**CONCEPTUAL MASTER
WASTEWATER SYSTEM REPORT
FOR
SERENO CANYON**

City of Scottsdale
Water Resources Department
Basis of Design Review Comments

Project: Sereno Canyon

Date: January 27, 2006

PLATE 4

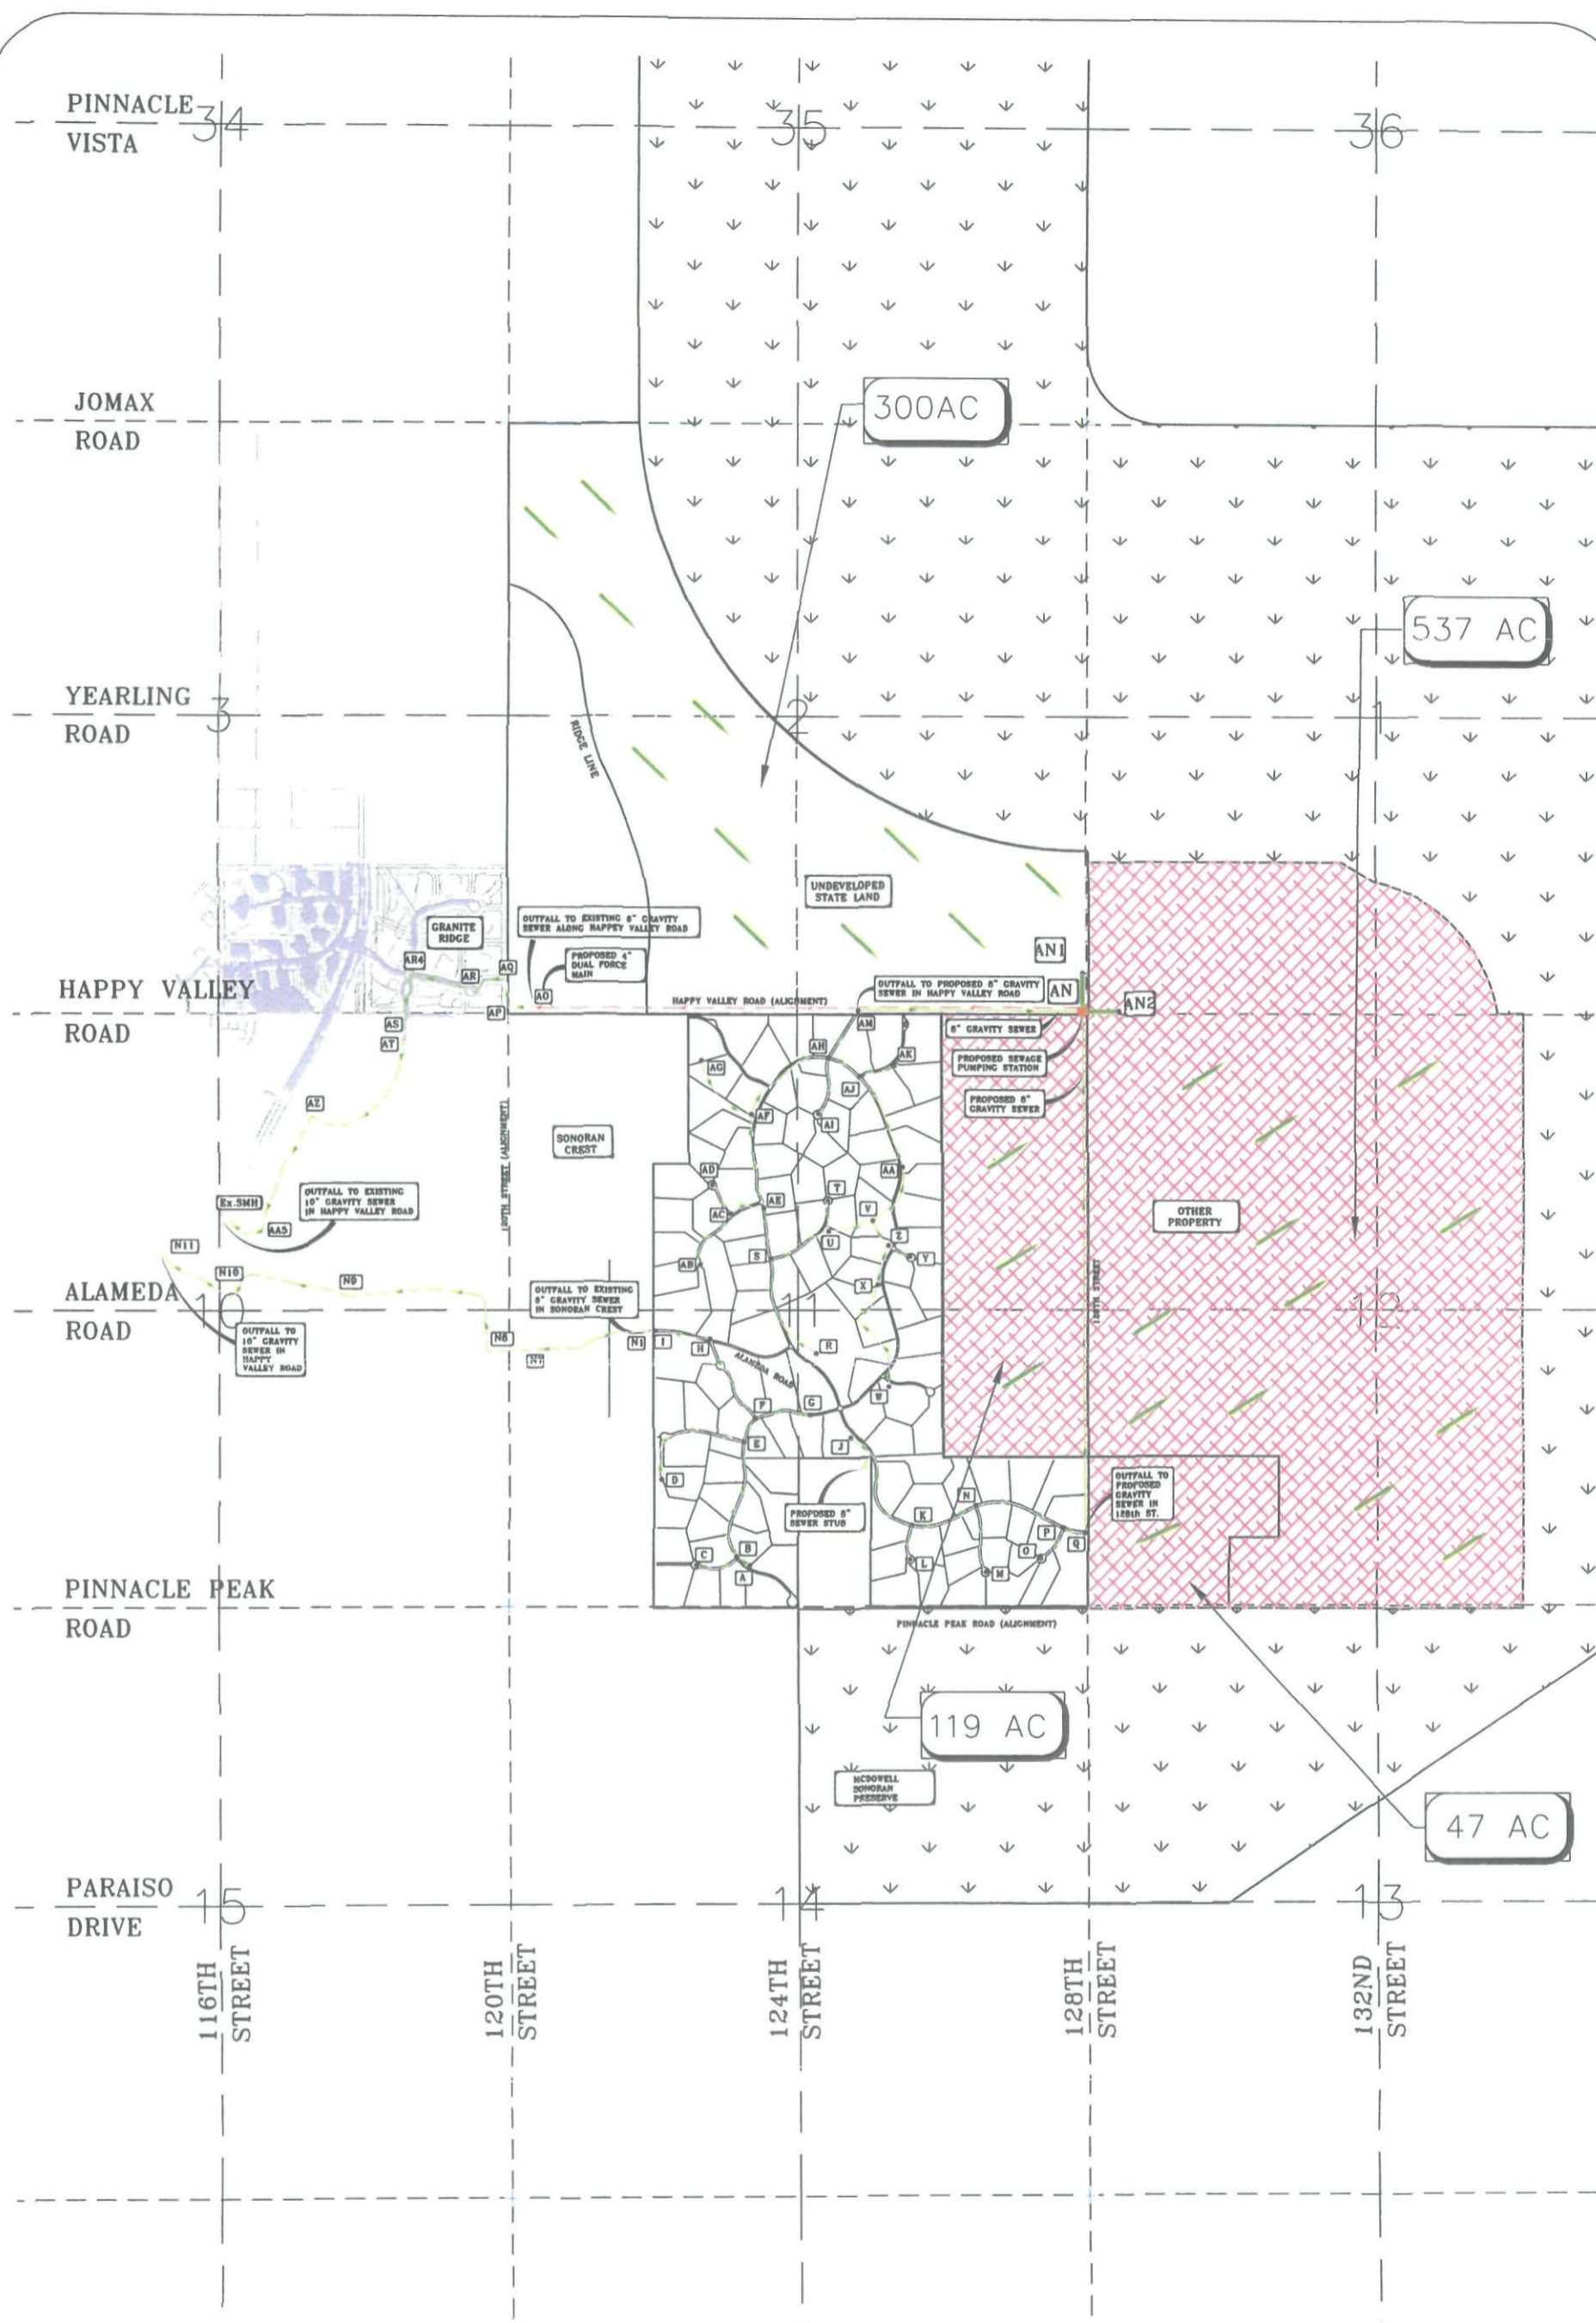
6. Any downstream capacity issues associated with the ultimate build out will be addressed in the City's master plan as a system deficiency.
7. I don't follow why there are options 1 and 2 associated with the ultimate build out.
8. There are some issues with the conceptual pump scenarios that we can resolve with the design report for the lift station.
